**DAMMON ENGINEERING INC**

Submittal Item: Pipe Bollards & Embeds  
Comments

Project Name: Stennis Riverine  
 Contract: N69450-05-D-0096  
 Ben Proj.: 3013-70  
 Submittal: 055000-01  
 Reviewed  
 Reviewed by: J. Collins  
 DATE: 3/26/09

COMBAT CRAFT OPERATIONS FACILITY  
 NASA JOHN C. STENNIS SPACE CTR. MISS.

SHEET 2

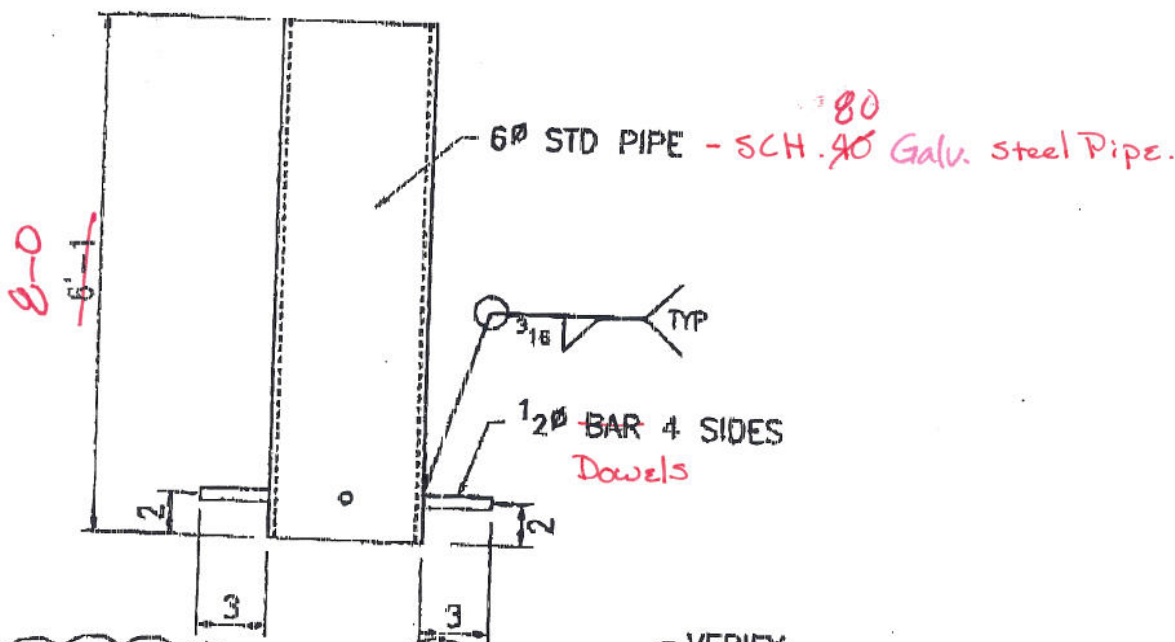
6 L'S 26'-0 LONG ✓

12 - Exterior  
~~24 - Interior~~ 6" STD PIPE PAINTED  
**36** ~~12~~ BOLLARDS  
 BOAT STORAGE BLDG.

Interior bollards  
 are being reviewed  
 weather or not they  
 stay will verify with  
 owner & Relay info to you - Not Req'd.

VERIFY

**BOLLARD DETAIL**

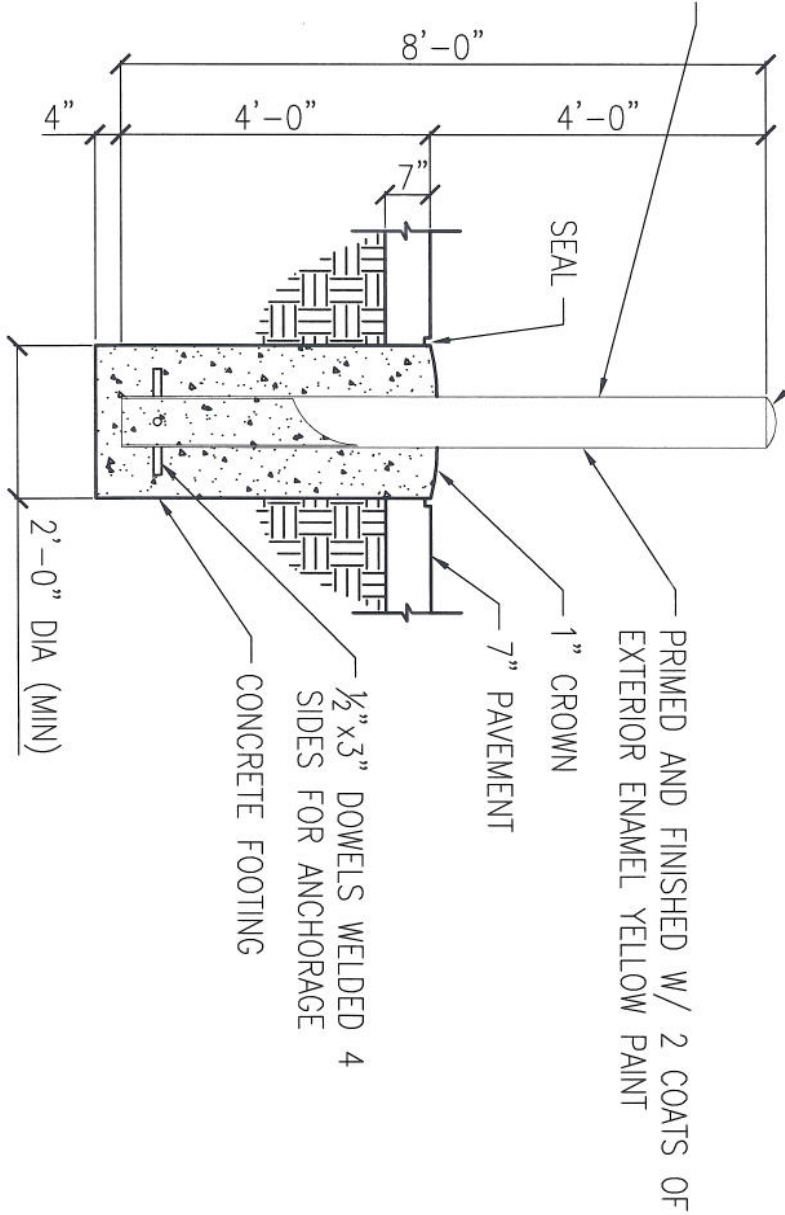
- Robert Walker
- Verify quantities & lengths.
  - See mark-ups.
  - Co-ord. w/O.H. door contractor.
  - Review revised bollard detail.

6" DIAMETER - SCHEDULE 80 GALV.  
STEEL PIPE. FILL POST WITH  
CONCRETE AND EMBEDDED IN A 3000 PSI  
PORTLAND CEMENT CONCRETE FOUNDATION
